HOUSE NO: 34

HOUSE TYPE: UC Special

MEMBER: GOLSKI

Project: VRAMBI COOPERATIVE

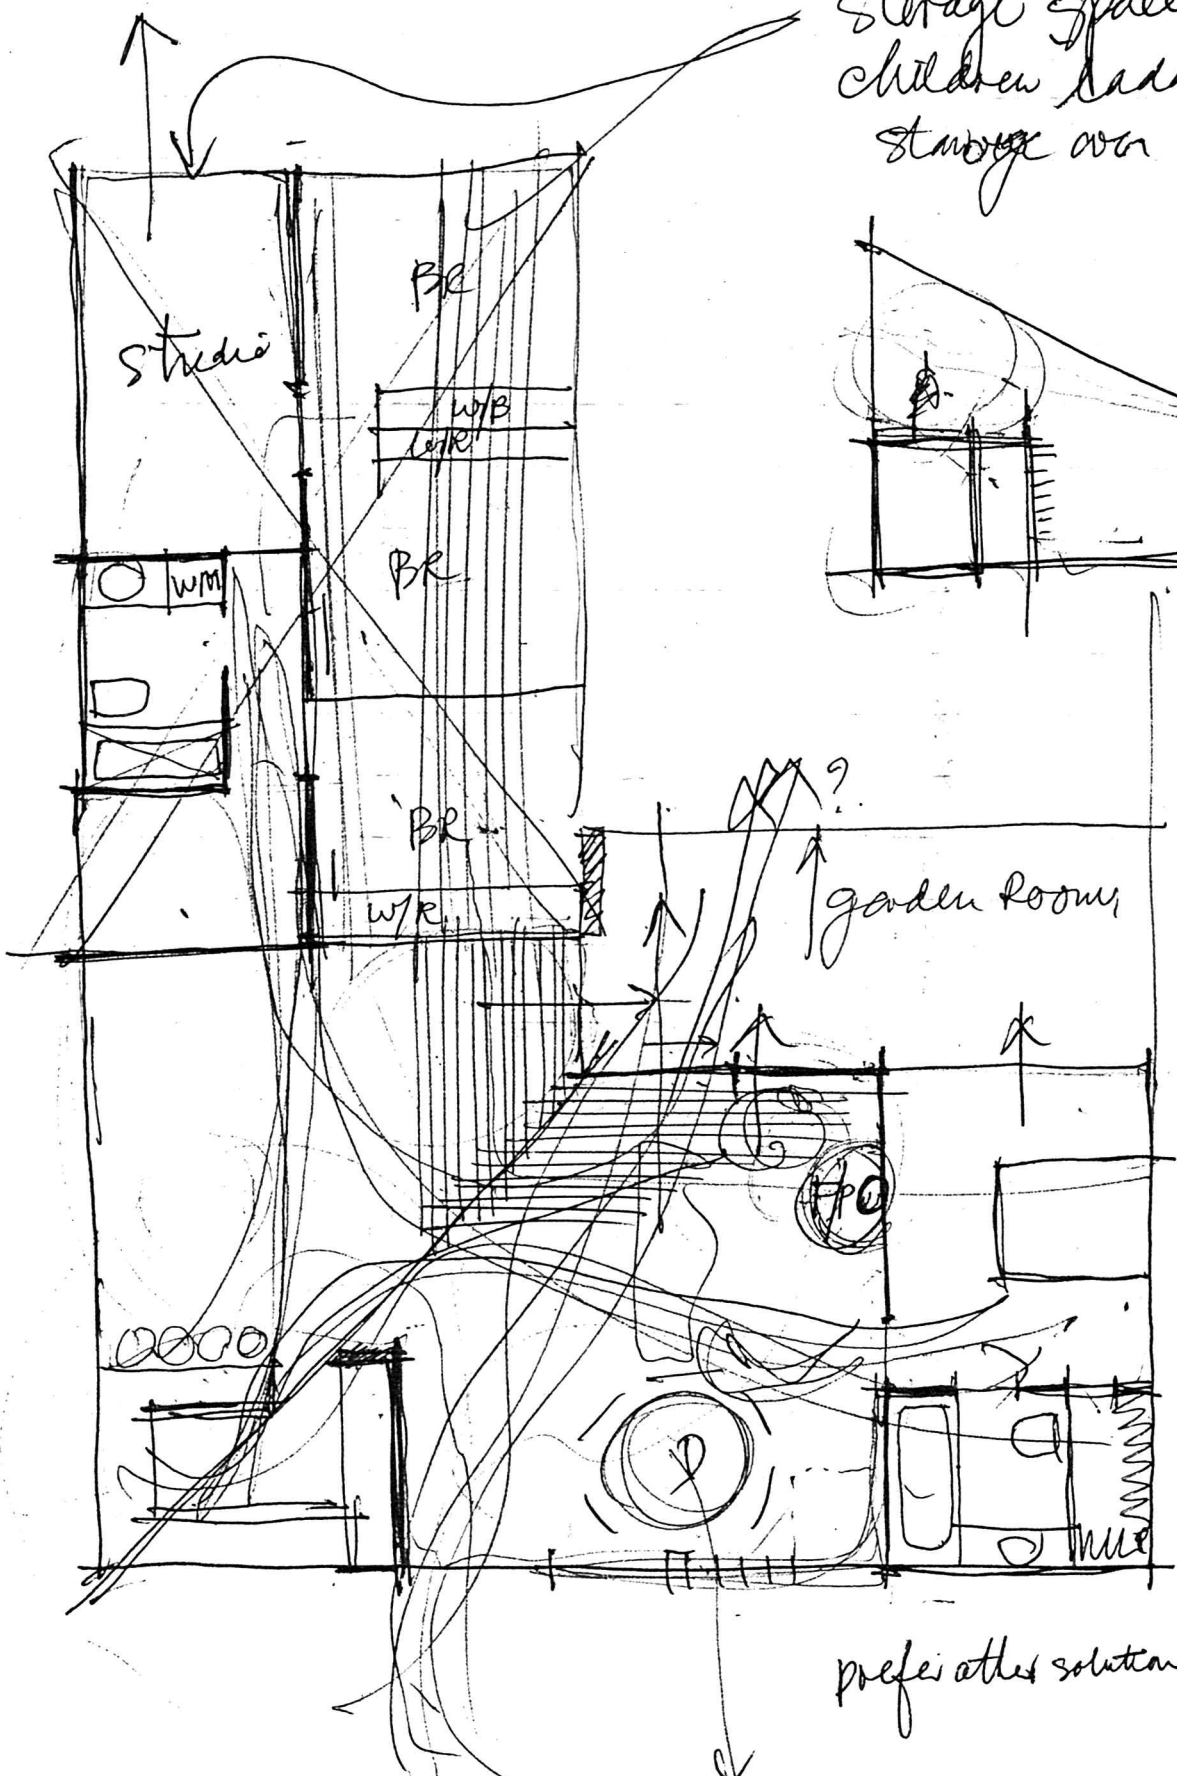
delete wall to BR S and make studied
increas in wall to living with WBR

- ✓ high wall to sloping ceiling timber living,
air lock and bath lobby. to WBR?
standard kitchen

No coat cupboard at entry

~~Plan~~ Mass angle + corners! paintings!
garden room.

- ✓ skylight to or space somewhere.

storage space over
children's beds +
storage over

prefer this solution

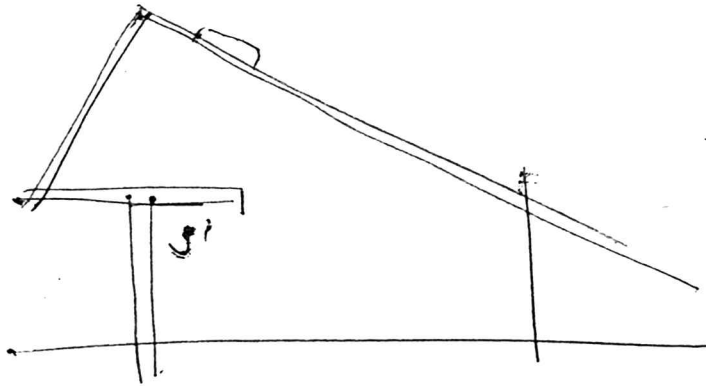
Eliminate wall between Study + BR
sc doors to BR 3 and 4

Platform including sloping roof space
extend on L.E. space 5' (design).
down lights to all decks.

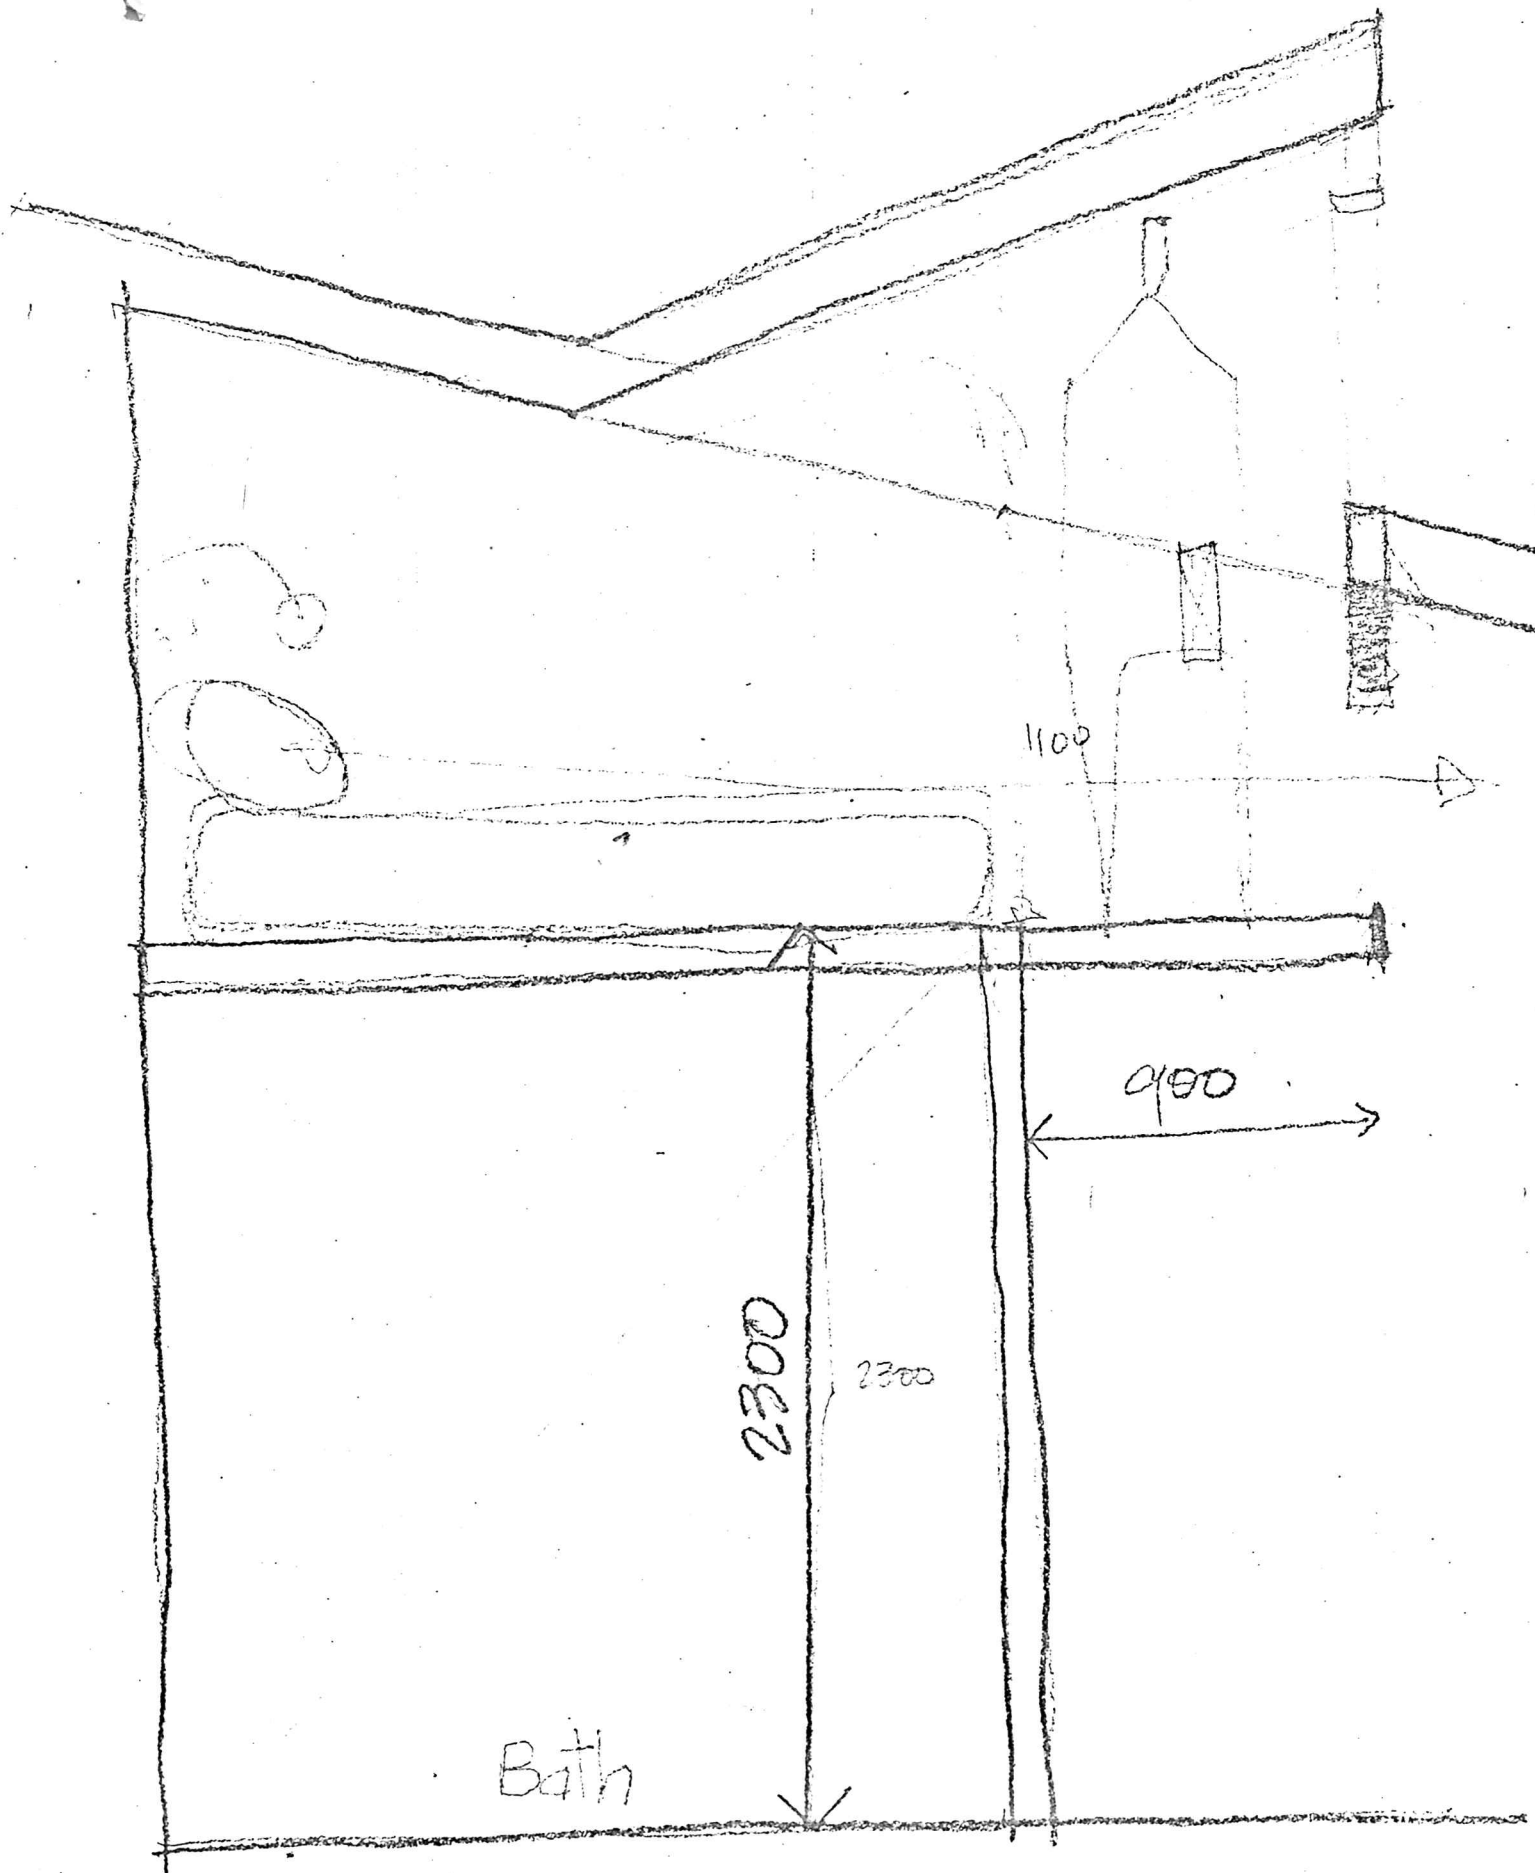
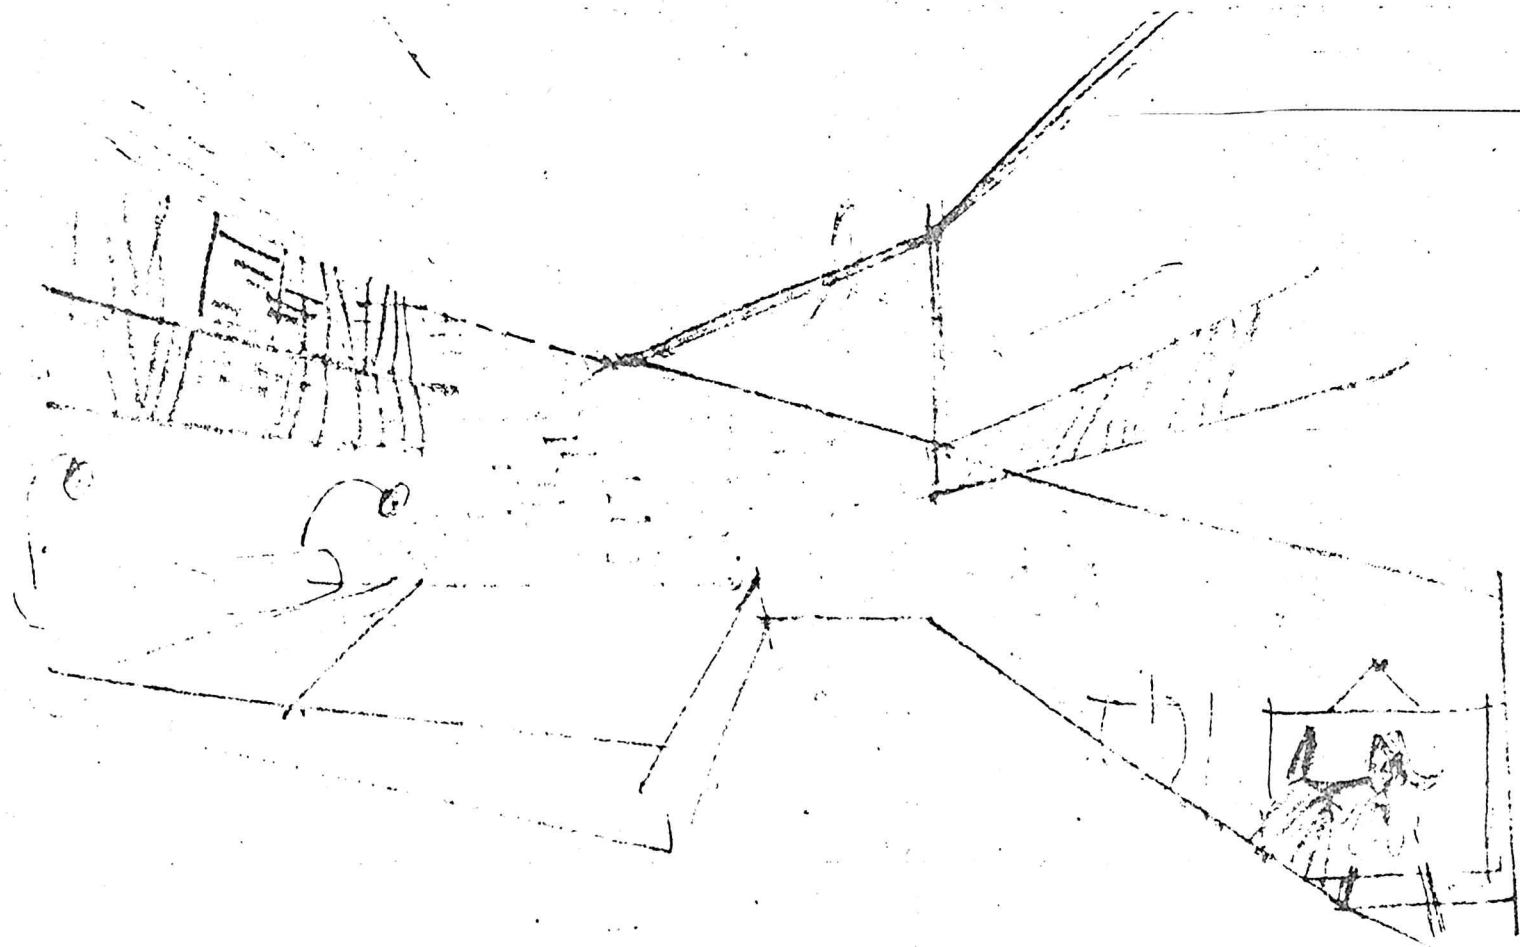
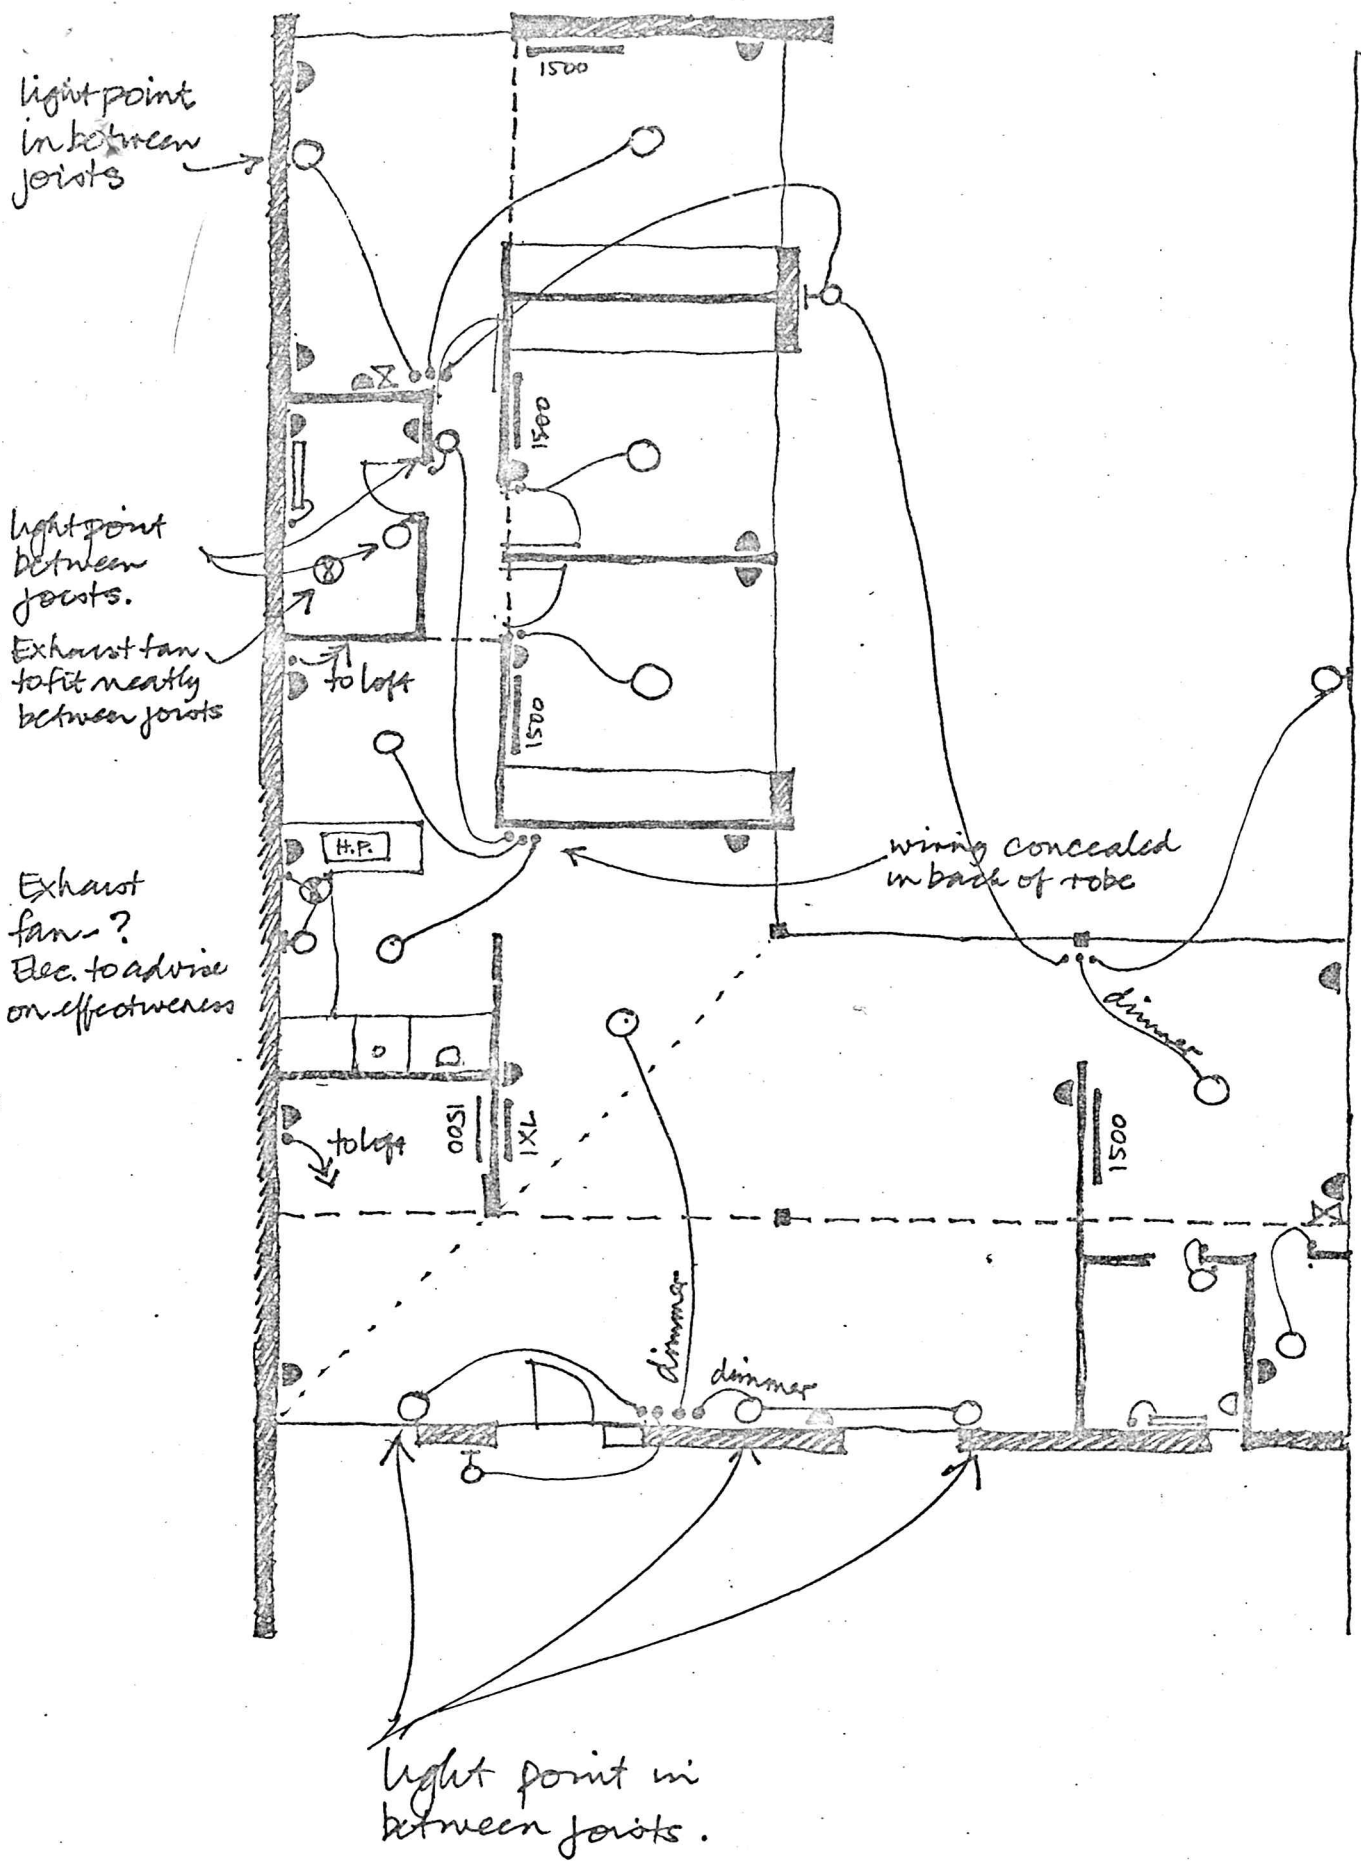
1. timber lined ceiling?
2. exposed joists?
3. loft over M Bed - Bath / Dr to continue through over Entry / Living / Study.
4. loft ~~of~~ over Bath / land. to continue ^{over} Study wall between study / Bed 2 to go.

rearrange this.

5. length of wall in B2/Study to be length of span beams - and approx 2'3" high.

* Michel D - definitely no rooflights. 20.7.76

Drop ceiling of bathroom to increase ceiling of childrens bedroom

Larger hotwater ^{cylinders} size 60 galls each
60 galls each

↳ seems a bit large for ensuite. PAB

LOFT - ELECTRICAL LAYOUT

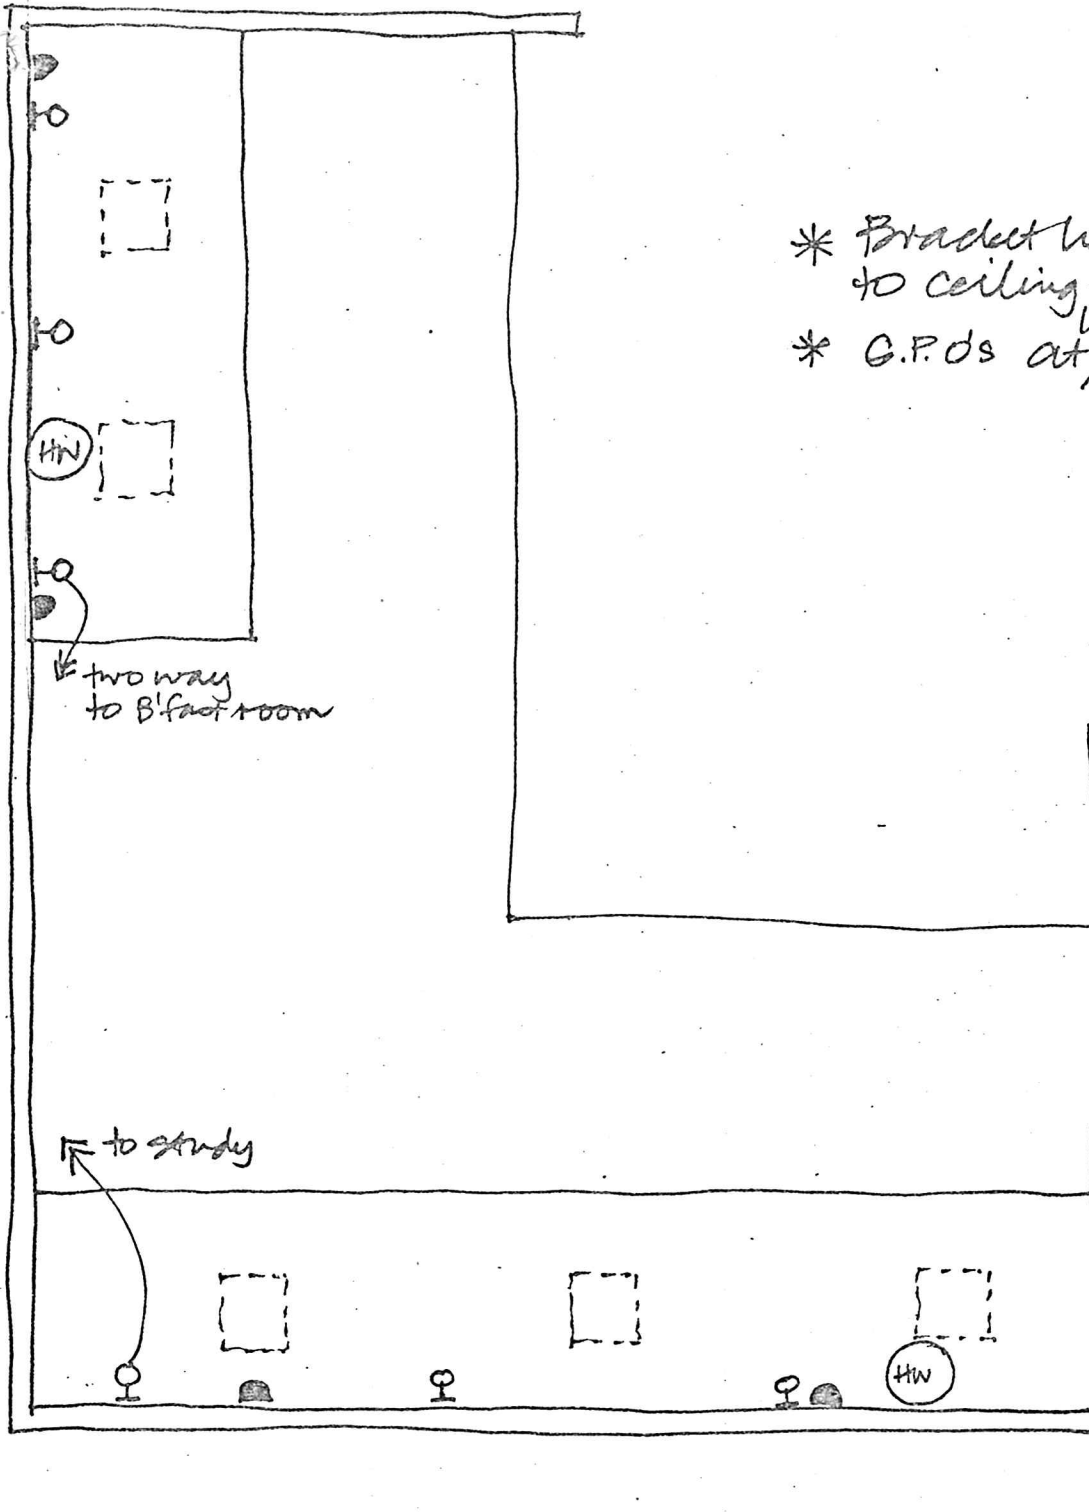
- * Bracket lights close to ceiling ^{loft} integral switch
- * G.P.Os at floor level
